Agenda Item # 6

MOD-003422-2025

- Modification of a previously approved Planned Unit Development

APPLICATION NUMBER 6 DATE August 21, 2025
 APPLICANT Ken Patel, A&R Development Group, LLC (James F. Watkins, Maynard Nexsen, PC, Agent)
 REQUEST PUD Modification

SITE PLAN

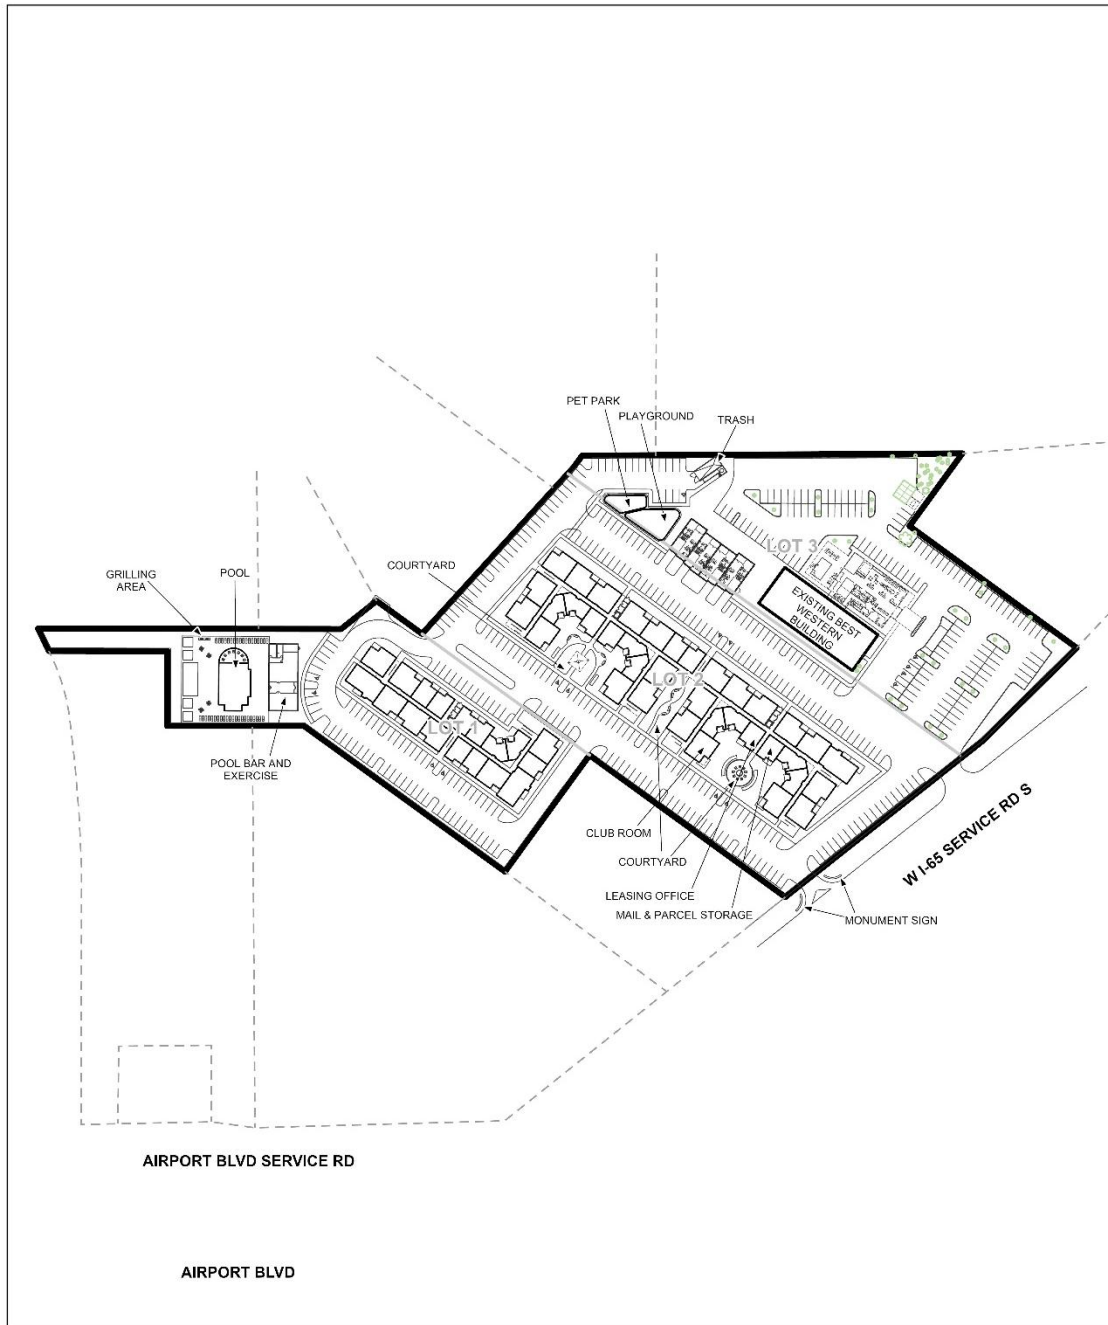
1. Label the drawing that was submitted (Sheet No. A0.2) as the PUD Site Plan.
2. Label all of the NEW or EXISTING buildings, structures, parking areas, trash receptacles, apartments, etc.

The site plan proposes the re-development of Lots 1 and 2, along with a portion of Lot 3, within the most recently approved subdivision and Planned Unit Development (PUD)—Shree Mahesh Subdivision—into a 221-unit multi-family residential complex. The development includes three (3) residential buildings, a leasing office, a pool pavilion with a fitness area, and one (1) trash compactor. Building 1, located on a portion of Lot 3, will contain

The site plan appears to depict a modification to the existing property line between Lot 2 and Lot 3. While this may reflect the revised PUD boundary, any alteration to property lines within an approved PUD must be consistent with the underlying subdivision. Therefore, re-subdivision is required to formalize such changes. If this is the case, the application must be held over until a Subdivision application is submitted for concurrent review by the Planning Commission, in accordance with Article 5, Section 64-5-1.D. of the Unified Development Code (UDC).

A 25-foot front yard setback is required along West I-65 Service Road South, per Article 2, Section 64-2-14.E. of the UDC. Upon approval, the Final PUD Site Plan must be revised to clearly illustrate this setback.

Table 64-3-12.1 of Article 3 of the UDC requires 1.5 off-street parking spaces per dwelling unit, necessitating 332 spaces for the 221-unit development. The site plan includes a parking table indicating 332 proposed off-street parking spaces for the multi-family units and 134 existing spaces for the hotel on Lot 3. However, the site plan scale does not allow staff to verify compliance with the dimensional standards of Table 64-3-12.2. Therefore, if approved, the Final PUD Site Plan should depict compliance with all off-street parking requirements, including quantity and dimensions, for all three lots.

It is unclear whether curbing or wheel stops are included where vehicles may extend beyond parking spaces. This should be noted on the revised site plan, or the Final PUD Site Plan should be updated to illustrate wheel stops and pedestrian walkways connecting each parking area to the respective buildings.

Recent aerial imagery indicates a sidewalk was constructed along West I-65 Service Road; however, it is not shown on the site plan. Additionally, no pedestrian walkways from the sidewalk to the proposed buildings are illustrated, which is required under Article 3, Section 64-3-3 of the UDC. Upon approval, the existing sidewalk and all required pedestrian walkways must be shown on the revised site plan.

Bicycle parking is neither depicted nor addressed on the parking table. The site plan should be revised to comply with bicycle parking standards outlined in Article 3, Section 64-3-12.A.9. of the UDC, including minimum quantities and location requirements.

Two-way traffic circulation is proposed, requiring 24-foot-wide drive aisles per Table 64-3-12.2. Due to the current scale, compliance cannot be verified. The site plan should be revised to show drive aisles with a minimum width of 24 feet, unless the design is reconfigured for one-way circulation, which requires a minimum 14-foot width.

Directional arrows indicating traffic flow should be included on the revised site plan and updated as necessary if circulation patterns change.

The size of each building should be labeled in square feet on a revised site plan or included in a table on the Final PUD Site Plan.

No tree plantings or landscaping are illustrated or quantified on the site plan. A note stating compliance with tree planting and landscape area requirements of Article 3, Section 64-3-7 of the UDC should be included on the Final PUD Site Plan. A landscaping plan will be required at permitting to verify compliance.

A trash compactor is shown on the site plan. A note referencing compliance with dumpster enclosure and placement standards of Section 64-3-13.A.4. of the UDC should be added to the Final PUD Site Plan.

1. Revision of the site plan to illustrate the required 25-foot front yard setback along West I-65 Service Road South;
2. Provision of lot sizes in square feet and acres, either directly on the revised site plan or via a table on the site plan;

3. Revision of the site plan to depict compliance with all off-street parking and drive aisle standards per Article 3, Section 64-3-12 of the UDC, including dimensions and two-way circulation requirements (unless reconfigured for one-way circulation);

4. Revision of the site plan to depict compliance with bicycle parking requirements, pursuant to Article 3, Section 64-3-12.A.9. of the UDC;
5. Revision of the site plan to illustrate directional arrows for on-site traffic circulation;

6. Revision of the site plan to depict curbing where vehicles could extend beyond the parking lot, or illustrate wheel stops where applicable;
7. Placement of a note on the revised site plan stating that the site will comply with parking lot lighting standards under Article 3, Section 64-3-9.C. of the UDC, and that a photometric plan will be submitted at the time of permitting;

8. Revision of the site plan to illustrate the existing sidewalk along West I-65 Service Road South;
9. Revision of the site plan to illustrate compliance with the pedestrian walkway requirements of Article 3, Section 64-3-3 of the UDC;

10. Revision of the site plan to label the size of each building in square feet or provide a corresponding table with the same information;
11. Provision of building elevation drawings demonstrating compliance with Article 3, Section 64-3-6 of the UDC, or placement of a note on the revised site plan stating that each new building will comply with these standards;

12. Revision of the site plan to illustrate compliance with tree planting and landscape area requirements of Article 3, Section 64-3-7 of the UDC, or placement of a note stating that a landscape plan compliant with these requirements will be submitted at the time of permitting;
